Access Compliance Report

Public Rights-of-Way

(Curb Ramps)

Intersection ID: 16469	Main Street: COLVILLE_RD	Cross Street: SCOTLAND_AV	Location: N
ADA ID: 70EEBF10B064	Ramp Type: PerpDiag	Initial Pass/Fail: Fail	Overall Compliance: No
Severity Score: 13.75			
Codes/Mitigation Info/Possible Solution		Field Measurements/Component Compliance

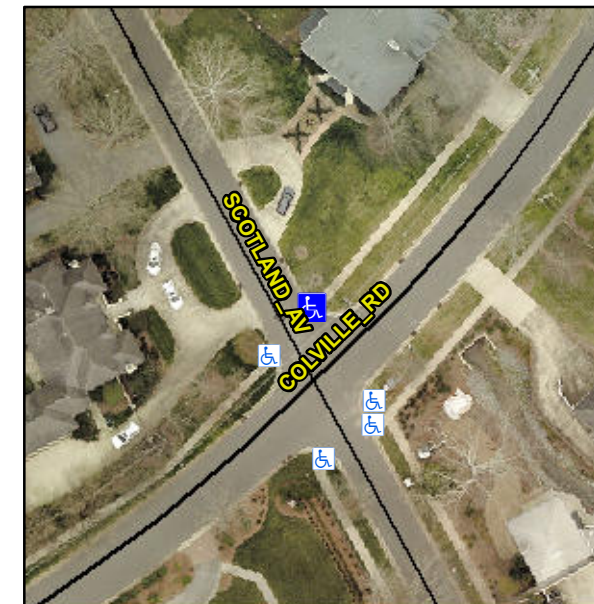
Not Found, R304.2.2, R304.5.3

Compliance	Description	Data	Compliance	Description	Data
N/A	Ramp Length (in)	95.5	No	Ramp Slope (%)	9.2
Yes	Ramp Width (in)	60.5	No	Ramp XSlope (%)	2.1
N/A	Flare Type LT	N/A	N/A	Flare Type RT	N/A
N/A	Flare Slope LT (%)	N/A	N/A	Flare Slope RT (%)	N/A
N/A	Flare Traversable LT?	N/A	N/A	Flare Traversable RT?	N/A
N/A	Landing Length (in)	N/A	N/A	DWS Provided?	N/A
N/A	Landing Width (in)	N/A	N/A	DWS Contrast?	N/A
N/A	Landing Slope (%)	N/A	N/A	DWS Length (in)	N/A
N/A	Landing X Slope (%)	N/A	N/A	DWS Full Width?	N/A
N/A	Landing Curb? (Y/N)	N/A	N/A	DWS Offset (in)	N/A
N/A	Shared Landing?	N/A			
N/A	Gutter Ponding?	N/A	N/A	Gutter Slope (%)	N/A
N/A	Gutter Lip Ht (in)	N/A	N/A	Gutter X Slope (%)	N/A
N/A	Painted X Walk1?	No	N/A	Painted X Walk2?	No
	X Walk 1 Direction	To SW		X Walk 2 Direction	To SE
N/A	X Walk 1 Width (in)	N/A	N/A	X Walk 2 Width (in)	N/A
	X Walk 1 Slope (%)	3.5		X Walk 2 Slope (%)	1.2
	X Walk 1 X Slope (%)	0.1		X Walk 2 X Slope (%)	2.4

Remove & Replace Curb Ramp With Two New Directional Ramps or Equivalent.
